MOORE PUBLIC SCHOOLS -
OLD SCHOOL REPLACEMENT
Moore Public Schools - Moore, Oklahoma
AGP - Moore, Oklahoma

ADDENDUM NO. 2
April 14, 2026

A303

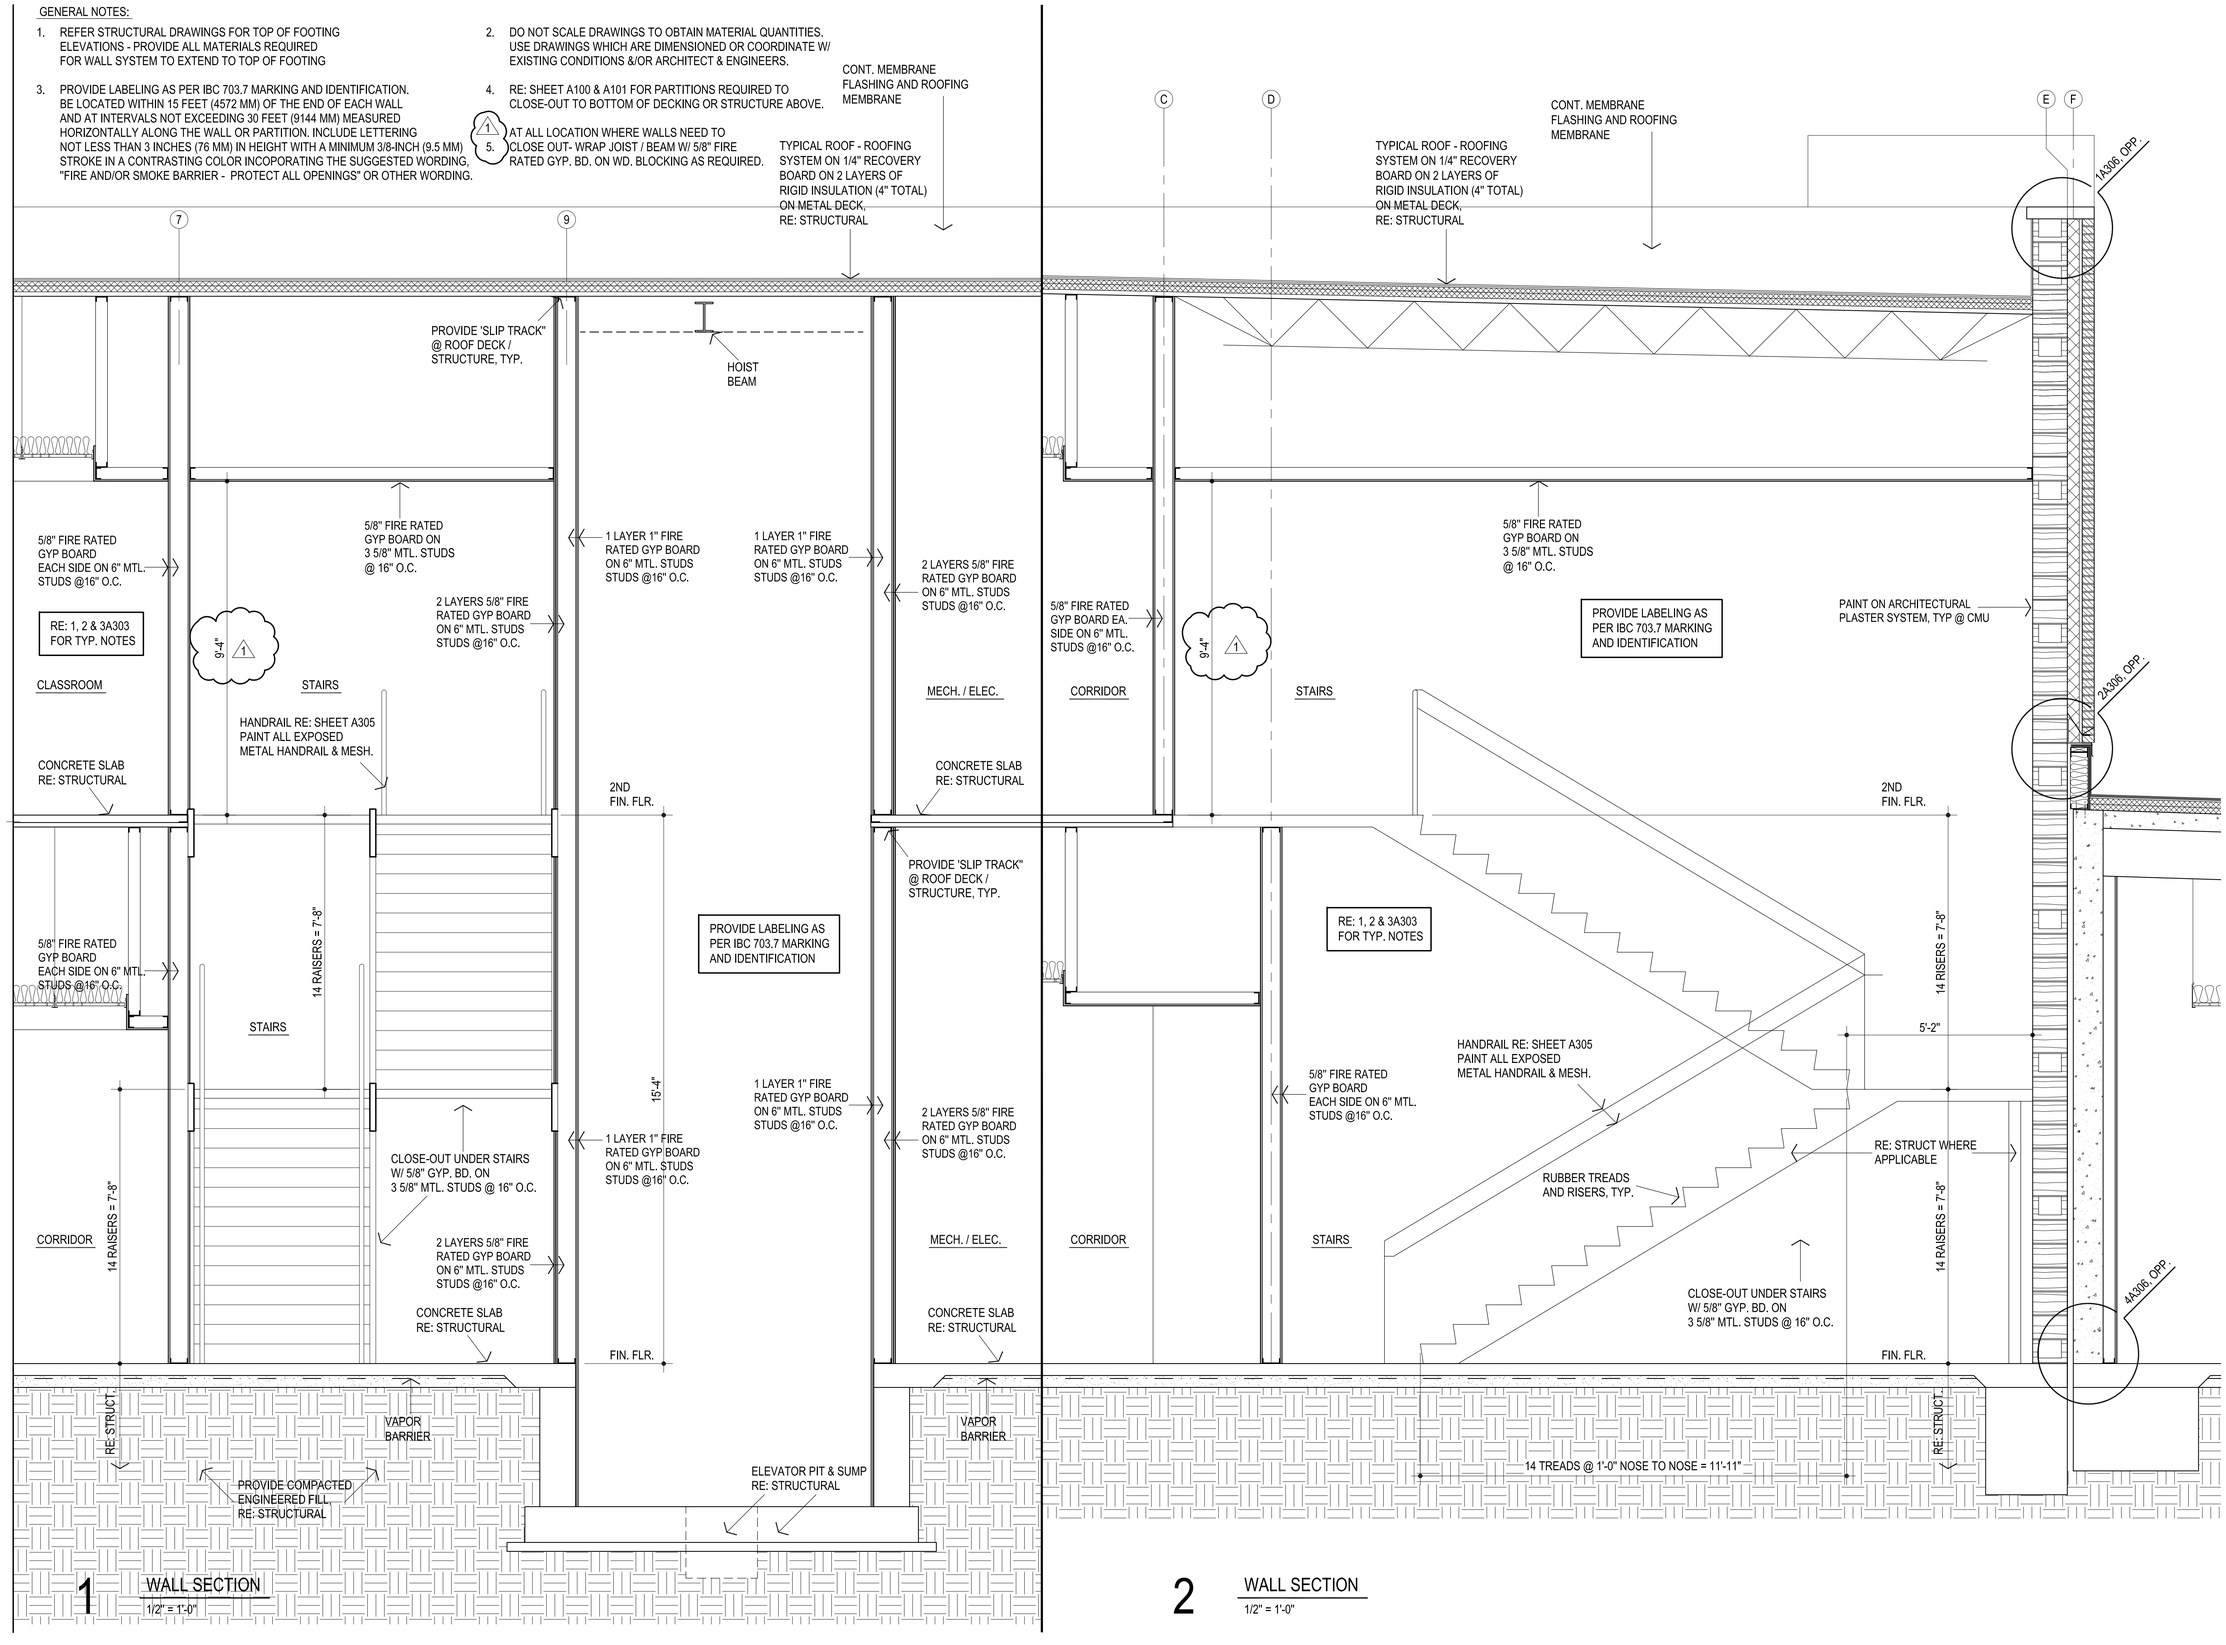
8. Sheet A303, Details #1, 2, 3, & 4, Wall Sections / Sheet A304, Details #1 & 2, Wall Sections / Sheet A305, Detail #1, Wall Section / Sheet A306, Details #7 / Sheet A307, Details #1 & 2, Wall Sections: revised noted dimensions to reflect changes in ceiling heights. Refer to attached revised drawings.

A306

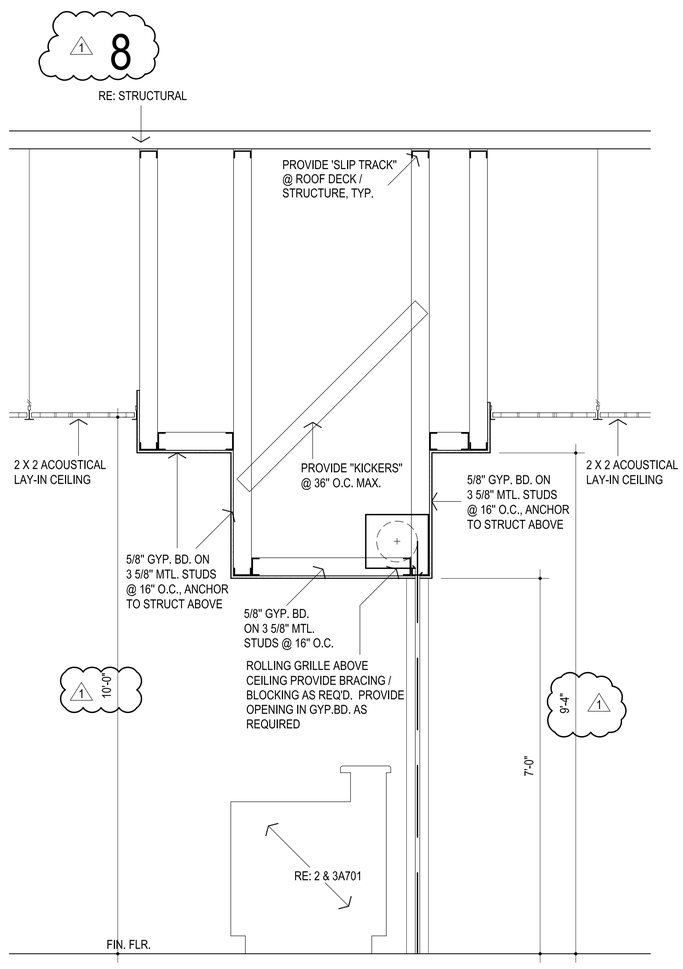
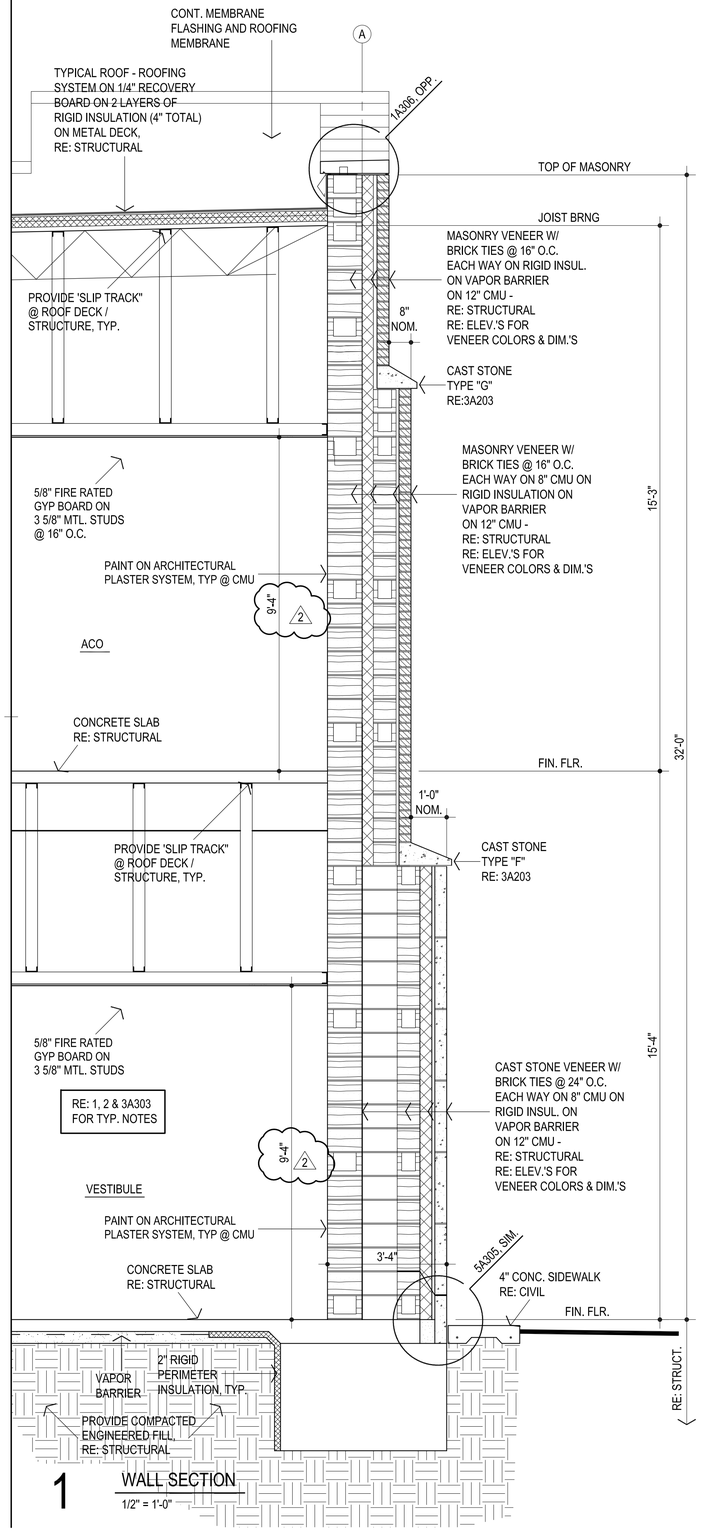
9. Sheet A306, Detail #8, Vertical Detail / Sheet A307, Details #3, 4, & 5, Vertical Details: details added / revised. Refer to attached revised drawings.

2 SOUTH EXTERIOR STAIR ELEVATION

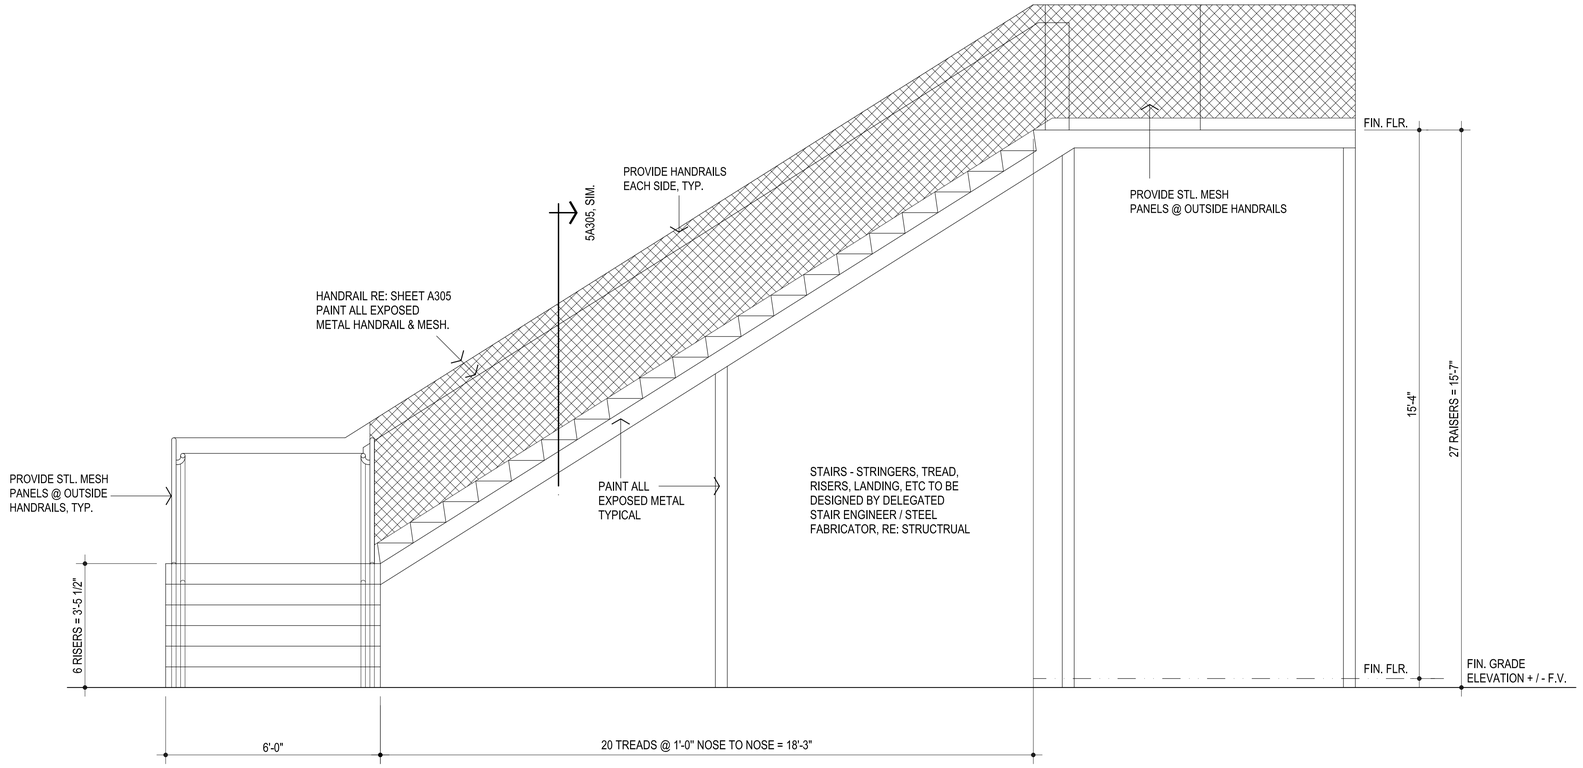
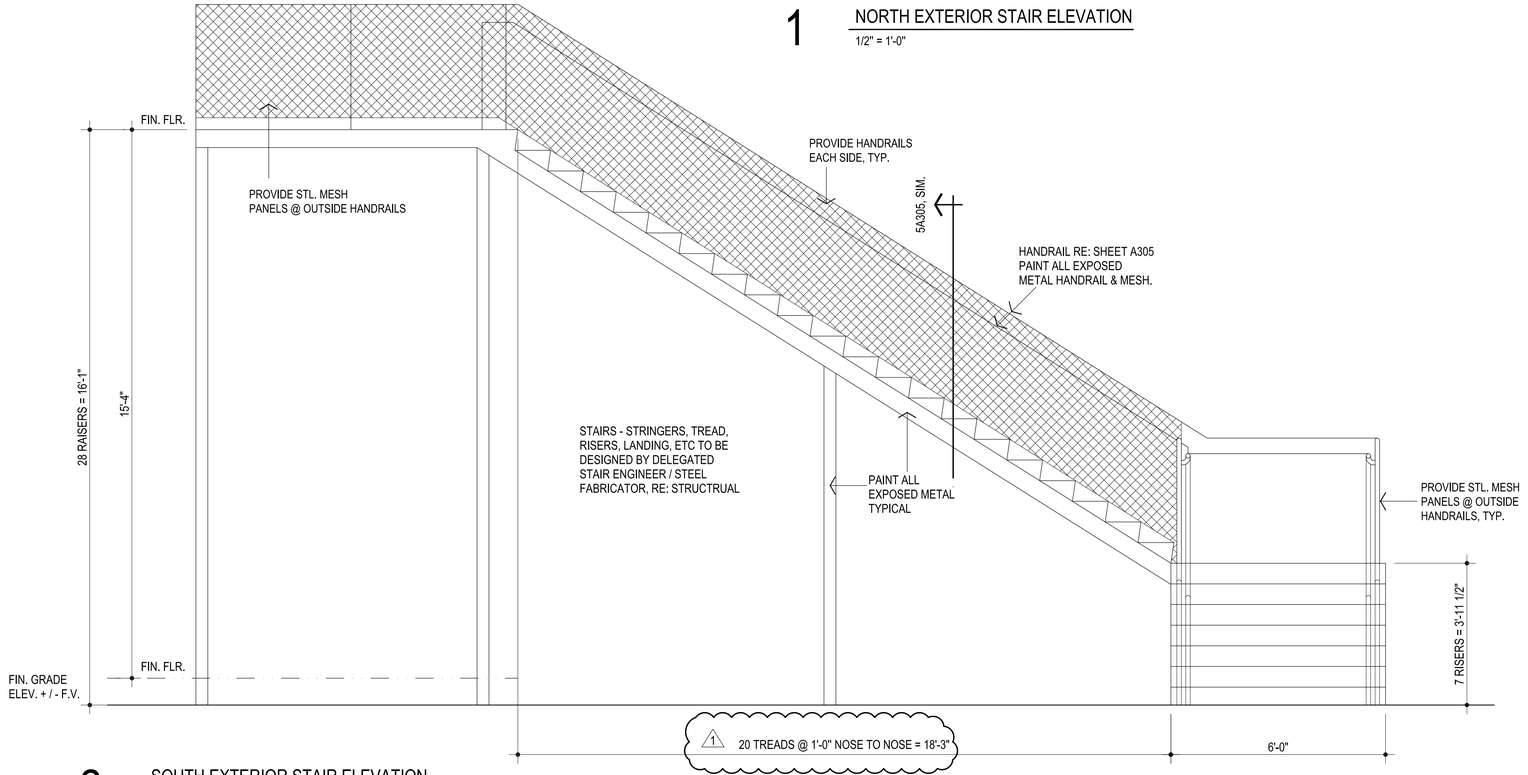
10. Sheet A308, Detail #2, South Exterior Stair Elevation: revised number of treads as indicated. Refer to attached revised drawing.

5 DOOR ELEVATIONS

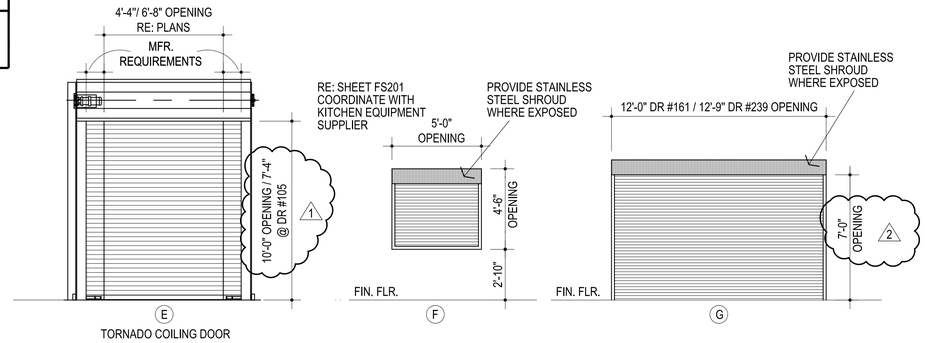
18. Sheet A602, Detail #5, Door Elevations and Detail #6, Door Frame Elevations1: revise door / door frame heights as indicated to accommodate changes in ceiling heights. Refer to attached revised drawing.
